CITY OF ARCADIA

Arcadia Planning Commission Regular Meeting Agenda

Tuesday, February 9, 2021, 7:00 p.m.

Figure 1 - Revised Site Plan

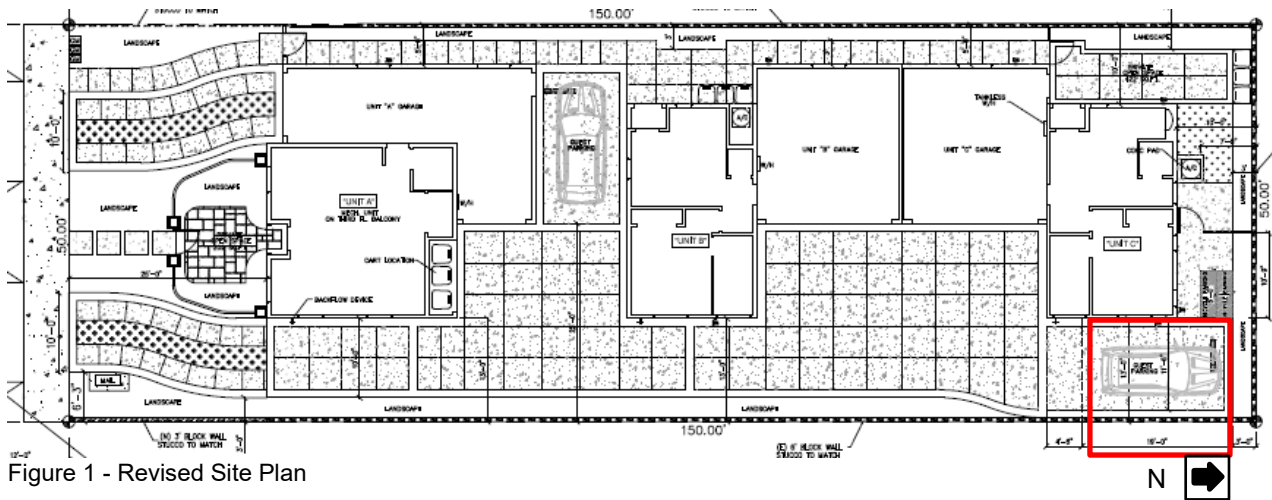
At the meeting, the Commission expressed concerns with both the current eviction laws and what authority the City has on this matter and whether vehicles can maneuver properly in terms of ingress and egress on the site due to the garage sizes and the building layout on this narrow lot. Although the staff report indicated that there are similar projects that were approved in the past by the Planning Commission, Commissioner Thompson referenced several articles and findings from a transportation engineer to support his analysis that the access is not functional. The third-party analysis submitted by Commissioner Thompson has been provided with this staff report – refer to the email and diagrams under Attachment No. 3. Vice Chair Lin and Commissioner Chan acknowledged that any development on these narrow lots tends to be tight since the buildings must also meet the minimum required setbacks. Further, the Development Code has a minimum garage dimension of 18'x19', which is not uncommon for multi-family developments. While there were concerns regarding the size and functionality of the proposed garage dimensions, Vice Chair Lin and Commissioner Chan stated that the project complies with the Development Code and felt that functionality concerns of the site's vehicular ingress and egress was not enough to deny the project. Commissioner Wilander felt that the site did not appear entirely functional and wanted additional information on this issue. In response to the Commissioner's comments and concerns, the Applicant presented images of the adjacent multi-family development, located at 155-159 Alice Street, which was approved with a similar vehicular ingress and egress configuration.

In response to the Commission’s concerns with egress from the garage of Unit C, the Applicant revised the site plan so that the rear guest parking space is closer to the rear property line which will provide an additional 4’-6” of maneuvering space for vehicles to back out. As shown below and under Attachment No. 4.

1. The guest space located at the rear of the property shall be moved forward 4'-6" to provide additional maneuvering space for vehicles to back out.
2. The 2'-0" landscaped strip along the east property line shall be replaced with concrete and become a part of the driveway area. This shall begin 40'-0" from the front property line to the end of the driveway.

Revised Site Plan & Response from
Applicant, dated February 2, 2021

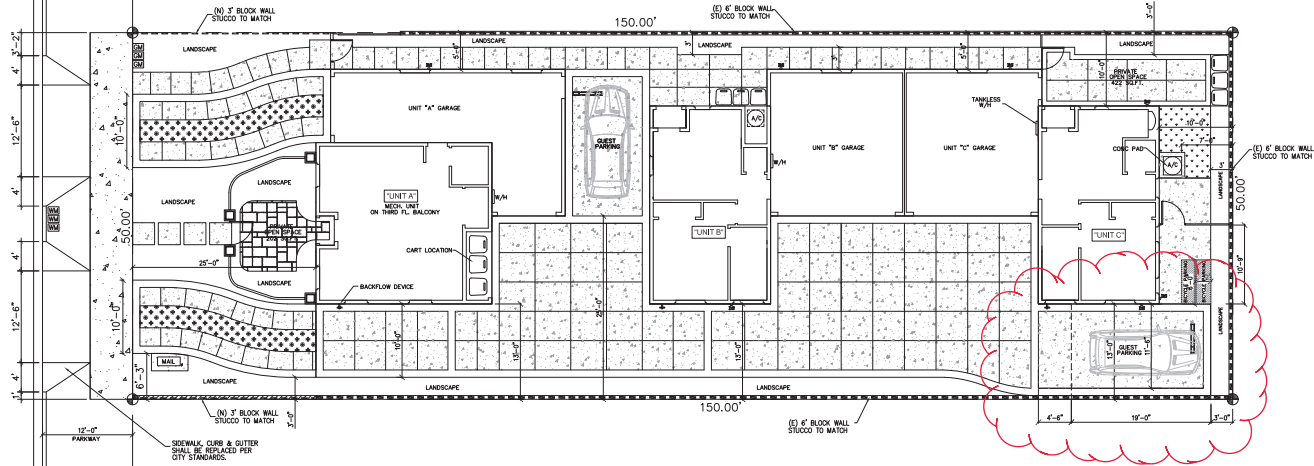
Thank you for your time in considering the project at 147 Alice Street. At the January 26, 2021 Planning Commission meeting, a concern was raised regarding the on-site maneuverability from certain parking stalls, with the last side-facing garage space being of most concern. It was questioned whether a vehicle parked in subject spot would be able to back out and exit with the provided 25' back out space. Commissioner Thompson suggested that the project be redesigned to two units to avoid this situation. As the public hearing is currently closed, I've prepared a list to address the statements:

- 1. The plans have been modified to provide a 4'-6" deep by 13'-0" wide space behind the open guest parking space to increase maneuverability from the garage spaces of the back unit.** Commissioner Thompson expressed concern about the adequacy of the back out space for Unit C's last garage space, especially when the back guest parking space is in use. To mitigate this concern, the guest parking space has been moved forward to provide a 4'-6" deep by 13'-0" wide area to increase maneuverability. A vehicle may now utilize that space behind the guest parking even when a vehicle is parked in the designated guest parking space. The actual clearance will likely be more than that considering the average car length is around 16'-0", and the provided parking space depth is 19'-0", plus a 3'-0" landscape buffer in front of the space.
